FDA-18-RFQ-1193058 Responses to Questions

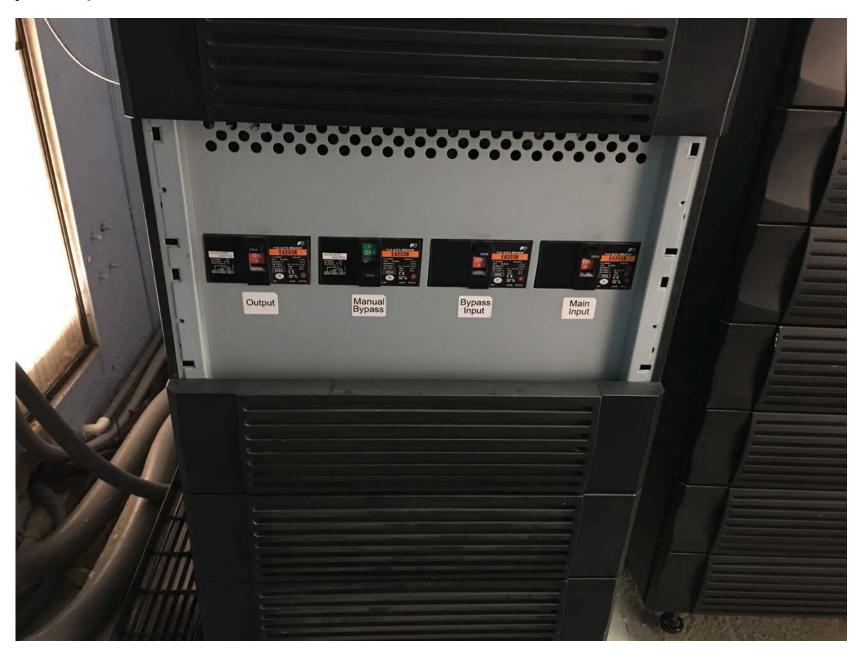
7) Please confirm if the job site has a loading dock or Forklift available for deliveries?	have forklift available. 8) See below
8) Are there electrical One line Diagrams available for the job site?	9) See below

9) Can you please provide some pictures of the current job site and of the existing electrical cutoff switch?	
It is important that the installation site be inspected to	At this time, we are not offering site visits, however please see the diagrams and
determine cable lengths and routing. Would this be possible?	pictures below.
Is it possible to provide detailed drawings of the project	See diagrams and pictures below.
area? If drawings are not possible a site visit would definitely help.	
definitely help.
